## ADDENDUM NO. 04

Project Name: Aston Township Municipal Complex

Project No.: 2301.00-22

Date of Issue: April 23, 2024

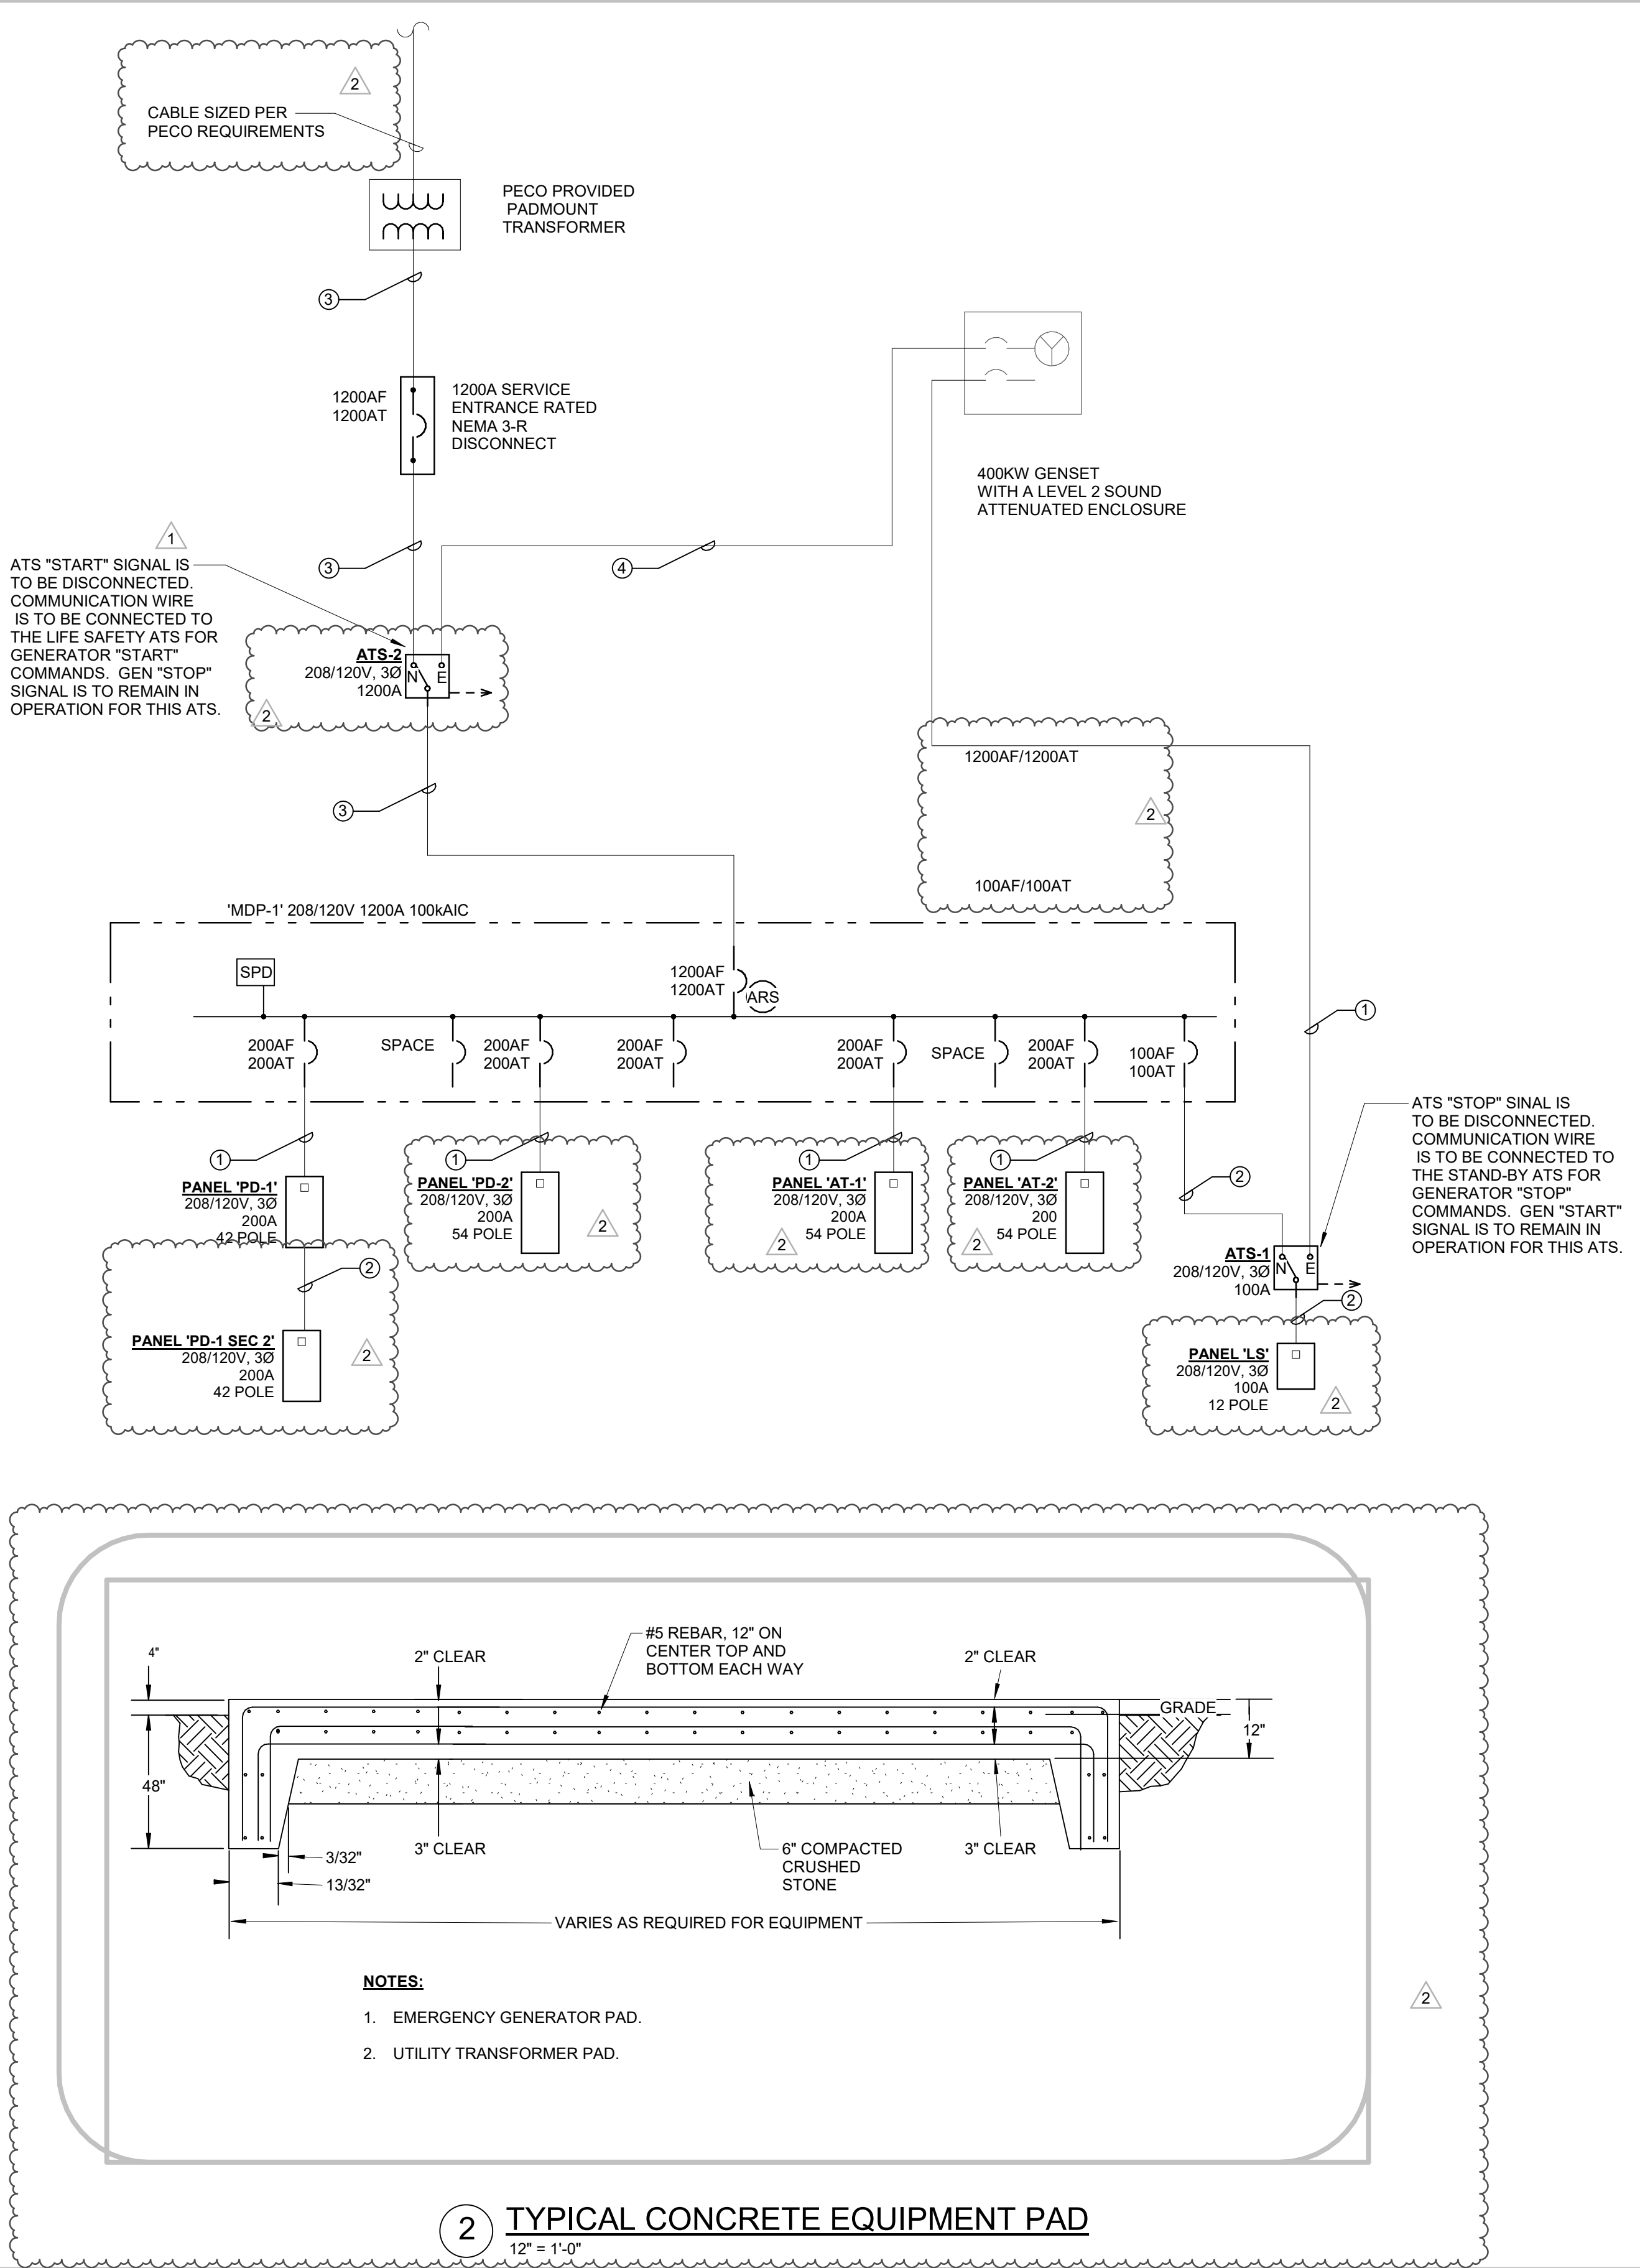
27. Reference to Sheet E-001 – Cover Sheet – Electrical: Sheet E-001 – Cover Sheet – Electrical is being reissued as part of this addendum. The Drawing List has been updated to reflect revised sheets contained in this addendum.
